1CAN091601

Subject: Initial Examination Completion of Post-Examination Analysis
Arkansas Nuclear One Unit 1 (B&W)
Docket No. 50-313

RO Final Written Examination Analysis

FIGURE 1
Saturation and Adequate SCM

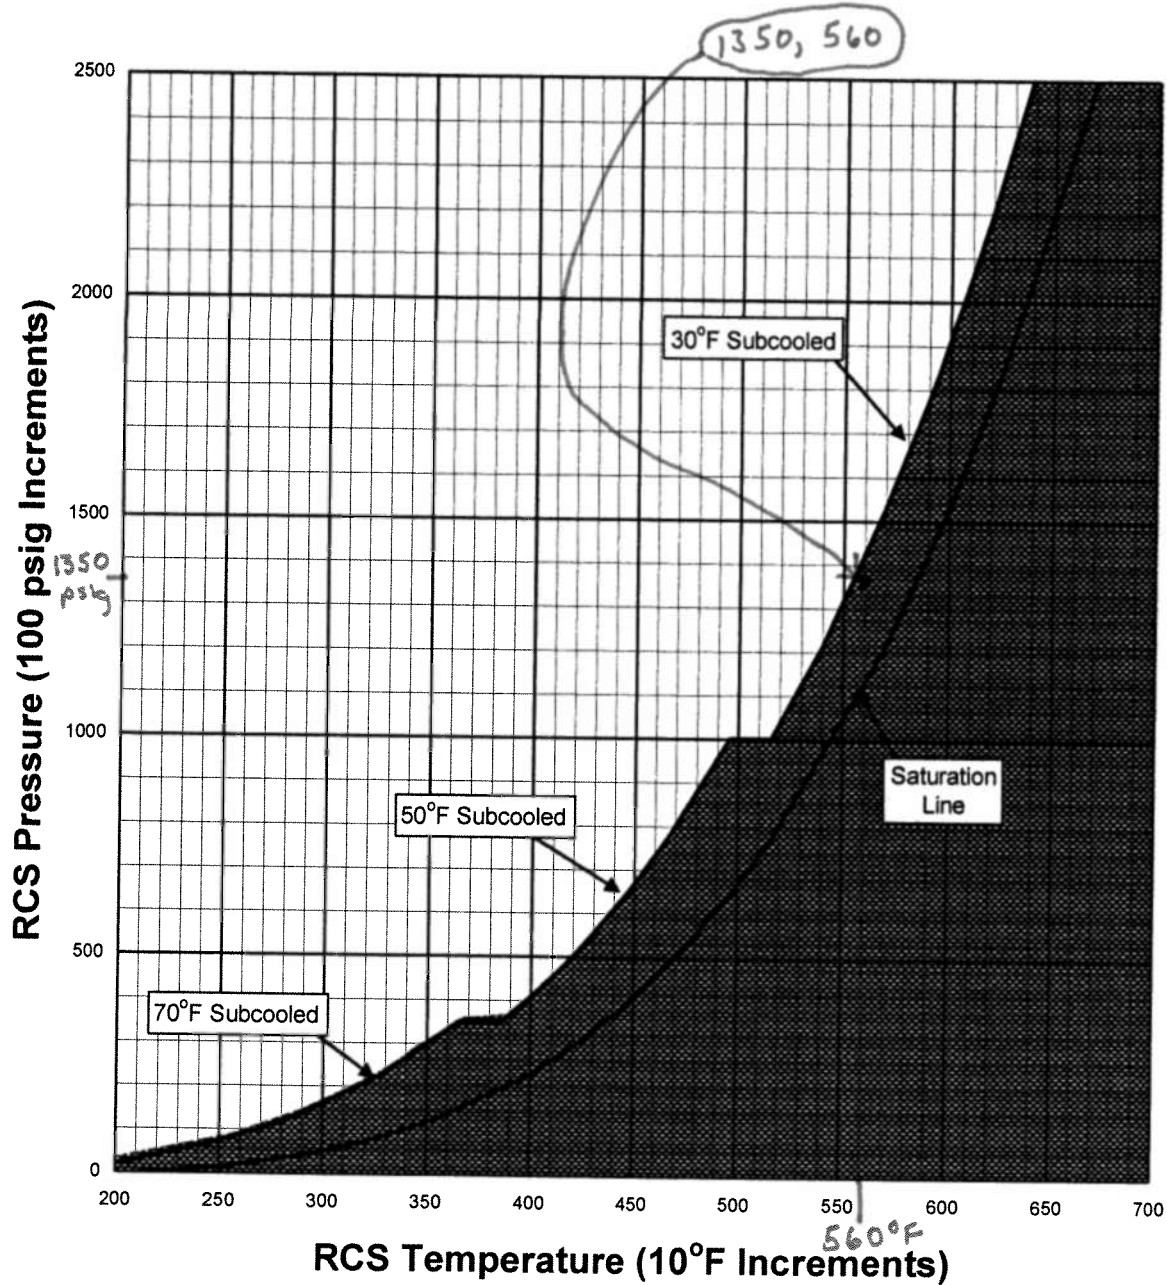
1. For 1202.013 Figure 1, "Saturation and Adequate SCM", what measure of RCS temperature is an operator required to use to determine SCM: CET temp, Tave, Thot, or something else?
2. Similarly, on the large LCD display mounted in the overhead to the left of the CRS desk in the control room, SCM is displayed from the plant computer. What measure of RCS temperature does this parameter use to calculate SCM?

1. CETs are used for calculating SCM.
2. The display on C19 (ICCMDS) gets its temperature from the CETs. The ATOG screen that is often up tracks Th and Tc to look for heat transfer upsets and it is plotted against a saturation curve and an adequate SCM curve. The Plant Data Server (PDS) and SPDS have the ATOG screens but there is no direct readout of SCM on the ATOG screen. There is also a ANO 1 SPDS Safety Function Display that uses CETs to calculate SCM. TI-1150A/B on C04 indicates SCM directly and uses CETs for an input. The Plant Computer is located to the right of the Turbine controls.
3. I can't find a value. Everything I find gives an indicating band like you stated 50 – 2300 F.
4. See attached file
